ADDENDUM #1 to the University of Florida ITN20RL-121 CORE Network Equipment Refresh scheduled to open on **Thursday November 14th, at 3pm** at the University of Florida, Elmore Hall Conference Room, Radio Road, Gainesville, Florida.

Vendor Questions ITN20RL-121 CORE Network Equipment Refresh

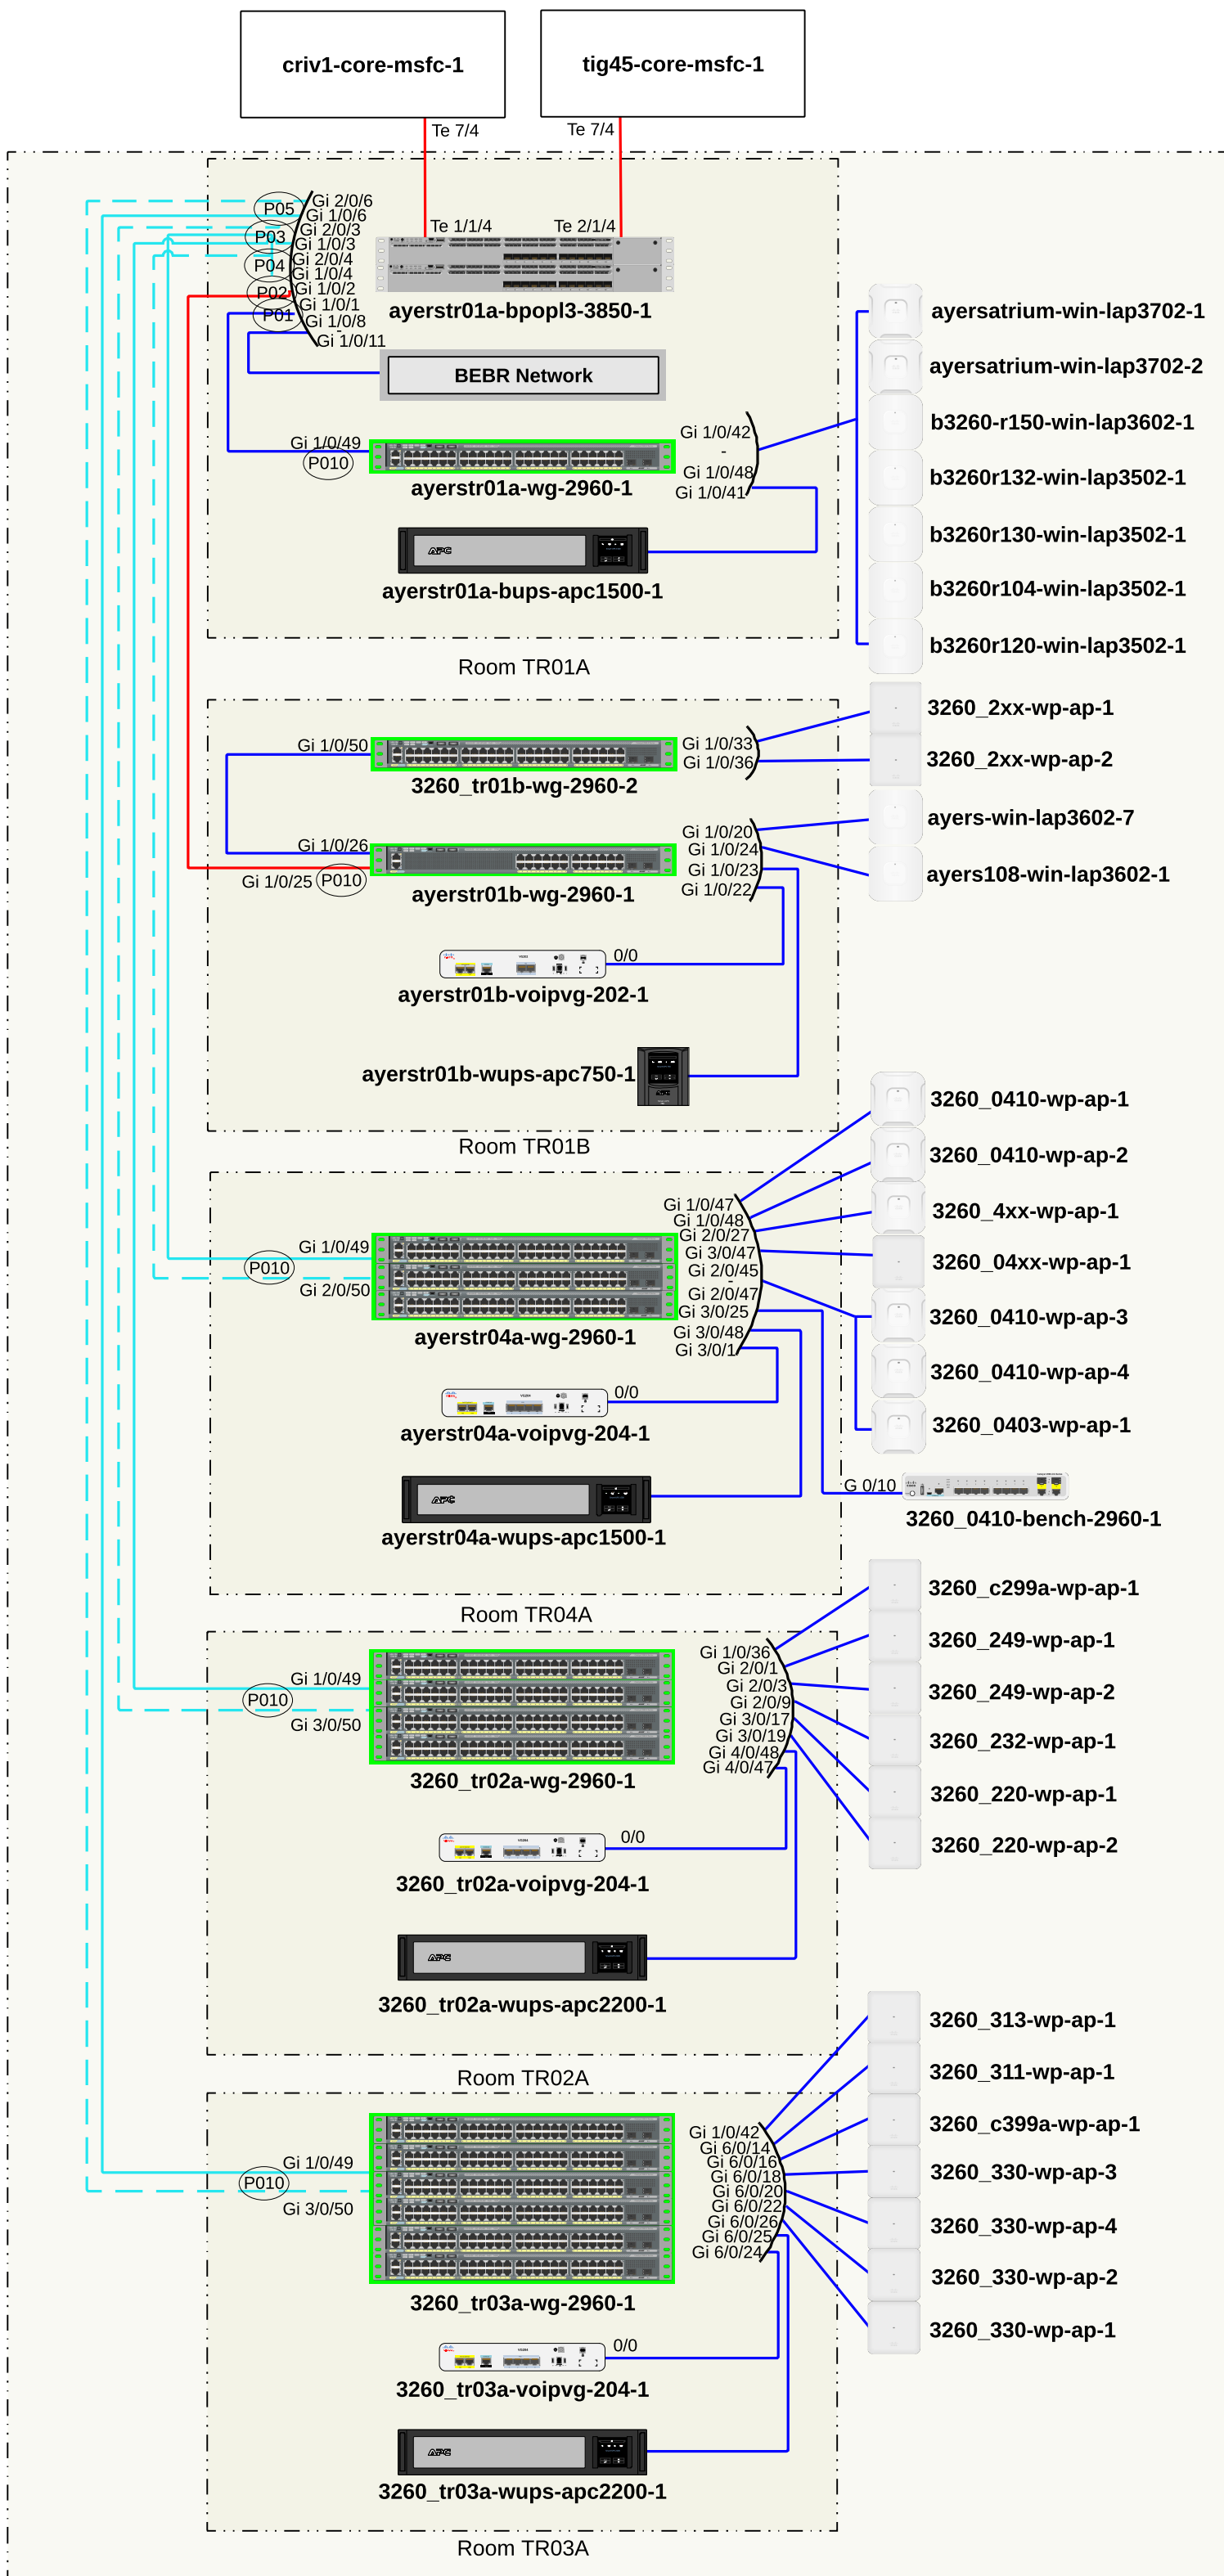
6) Question: Can you provide a detailed diagram listing the connections between the TOR switches and the Catalyst 6506/6509?

Answer: Each core router has 30-50 connections to buildings, at rates between 1G and 10Gbps. The edge layer 3 switch is currently a 3850 or 9500 (some limited 3750s, but those are going away). These switches are either straight layer 3 / OSPF or MPLS back to the core. There are no "TOR" switches per se. Each building has 2 connections back to two independent core routers (layer 3 or MPLS). Please see the example building level diagram below:
